MAINE TURNPIKE AUTHORITY

ADDENDUM NO. 1

CONTRACT 2018.17

AUBURN EXIT 75
TOLL SYSTEM UPGRADES
AND STREAM RELOCATION (MM 75.3)

SHEET NUMBER: S-02
CONTRACT: 2018.17
76 OF 84

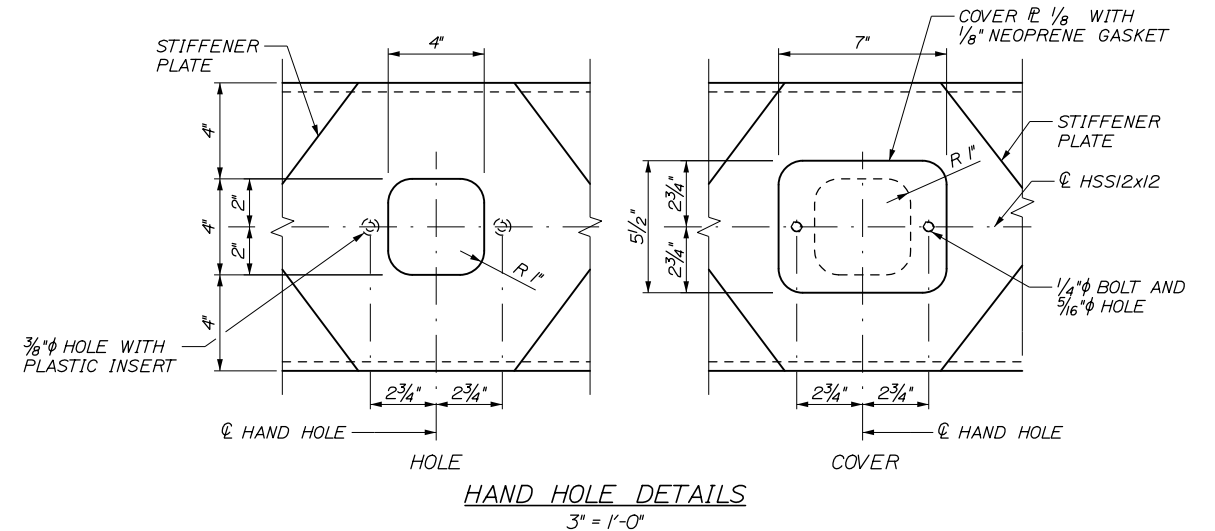
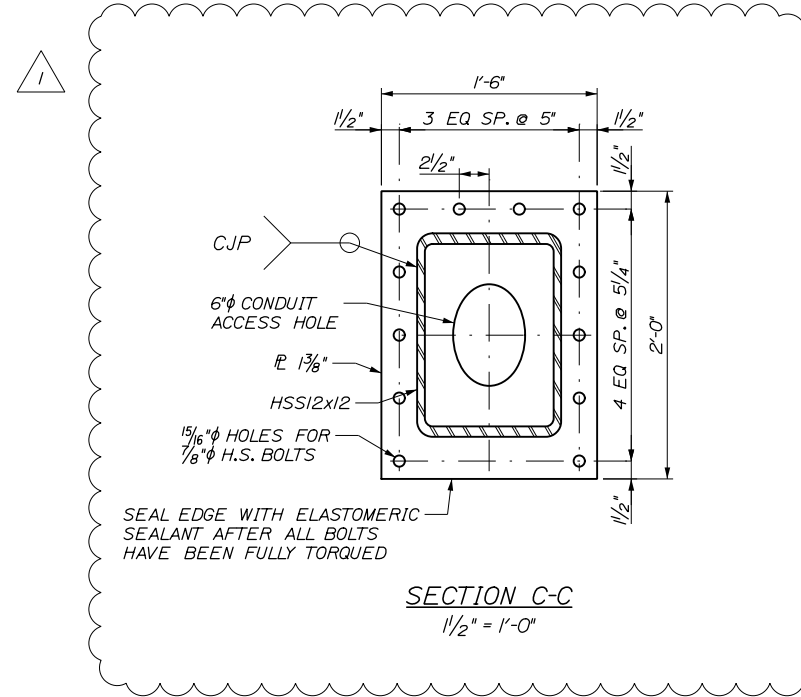
Question 8: Issue with bolt up of the bottom (2) bolts at the gantry beam and column connection. The bolts need to be 4" long and the space is only 2"?

Answer: This detail has been amended, see attached plan sheet.

No.	Revision	By	Date
1	Connection Bolt Update	GLS	06/14/18
